Re: KUCC South Facilities Final Remedial Design Work Plan

## South Facilities Groundwater Remedial Design Work Plan

Prepared By: Kennecott Utah Copper  
Date: August 6, 2001  
Version C

Re: Responses to Comments on the KUCC South Facilities  
Draft Remedial Design Work Plan

LEGEND	FIGURE 2-1	KUCC SOUTH FACILITIES RD
----- communication	Prepared by: JCC	
----- authority	Date: 8/3/01	PROJECT ORGANIZATION

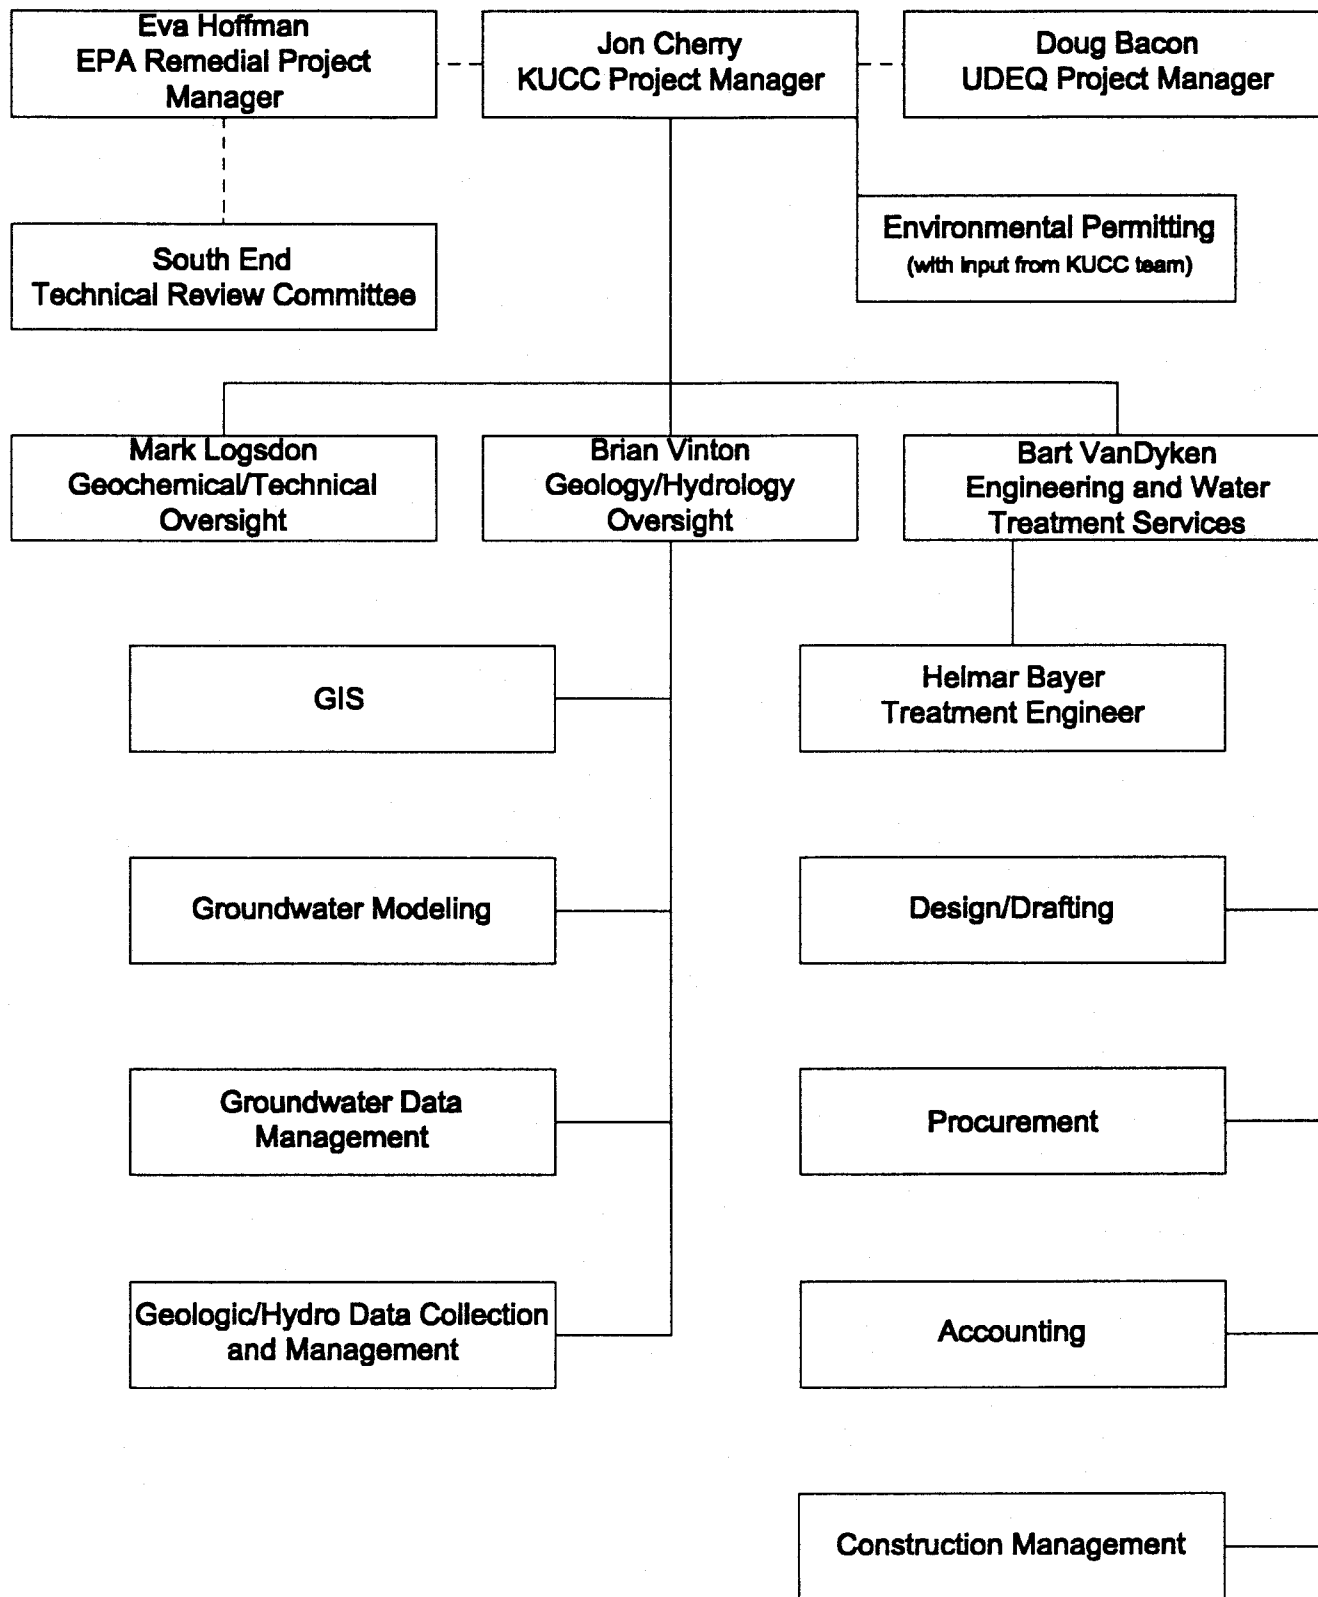
*(28) Figure 2-1 KUCC South Facilities RD - Project Organization, page 22. Please indicate who is responsible for permitting issues.*

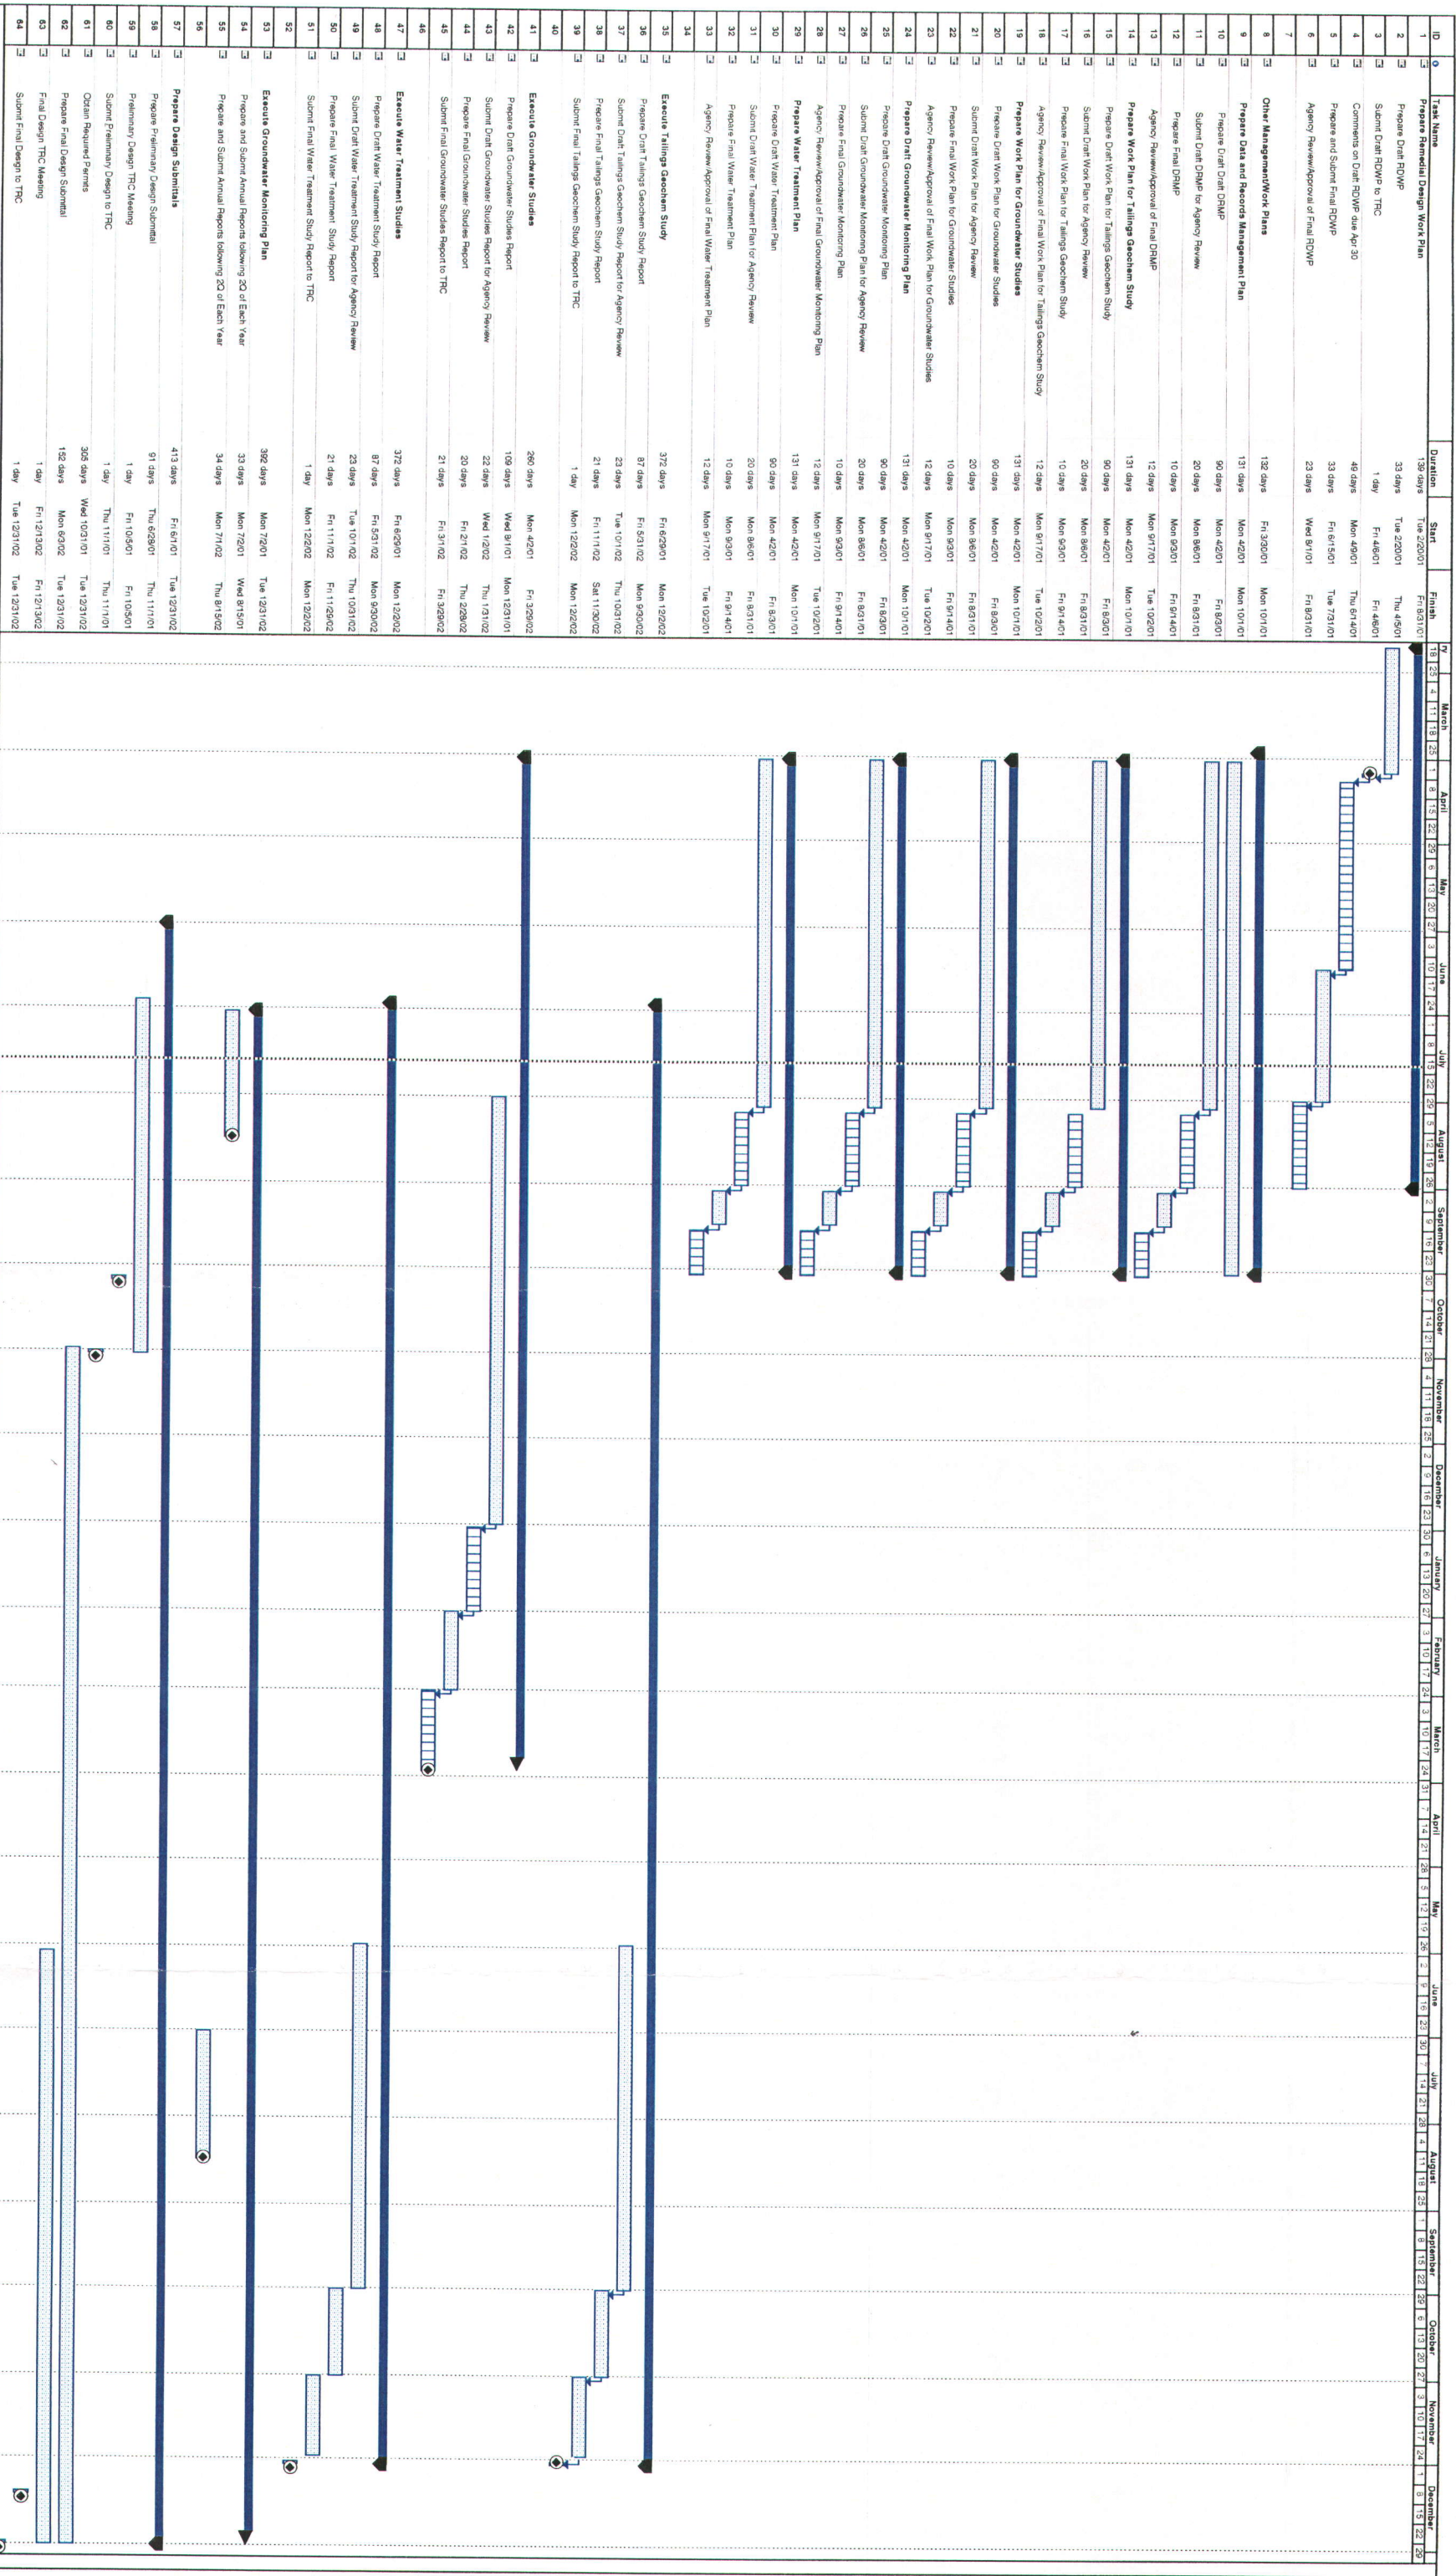
4. *Figure 7-1, page 40. Revise the project schedule to incorporate actual dates for completed tasks.*
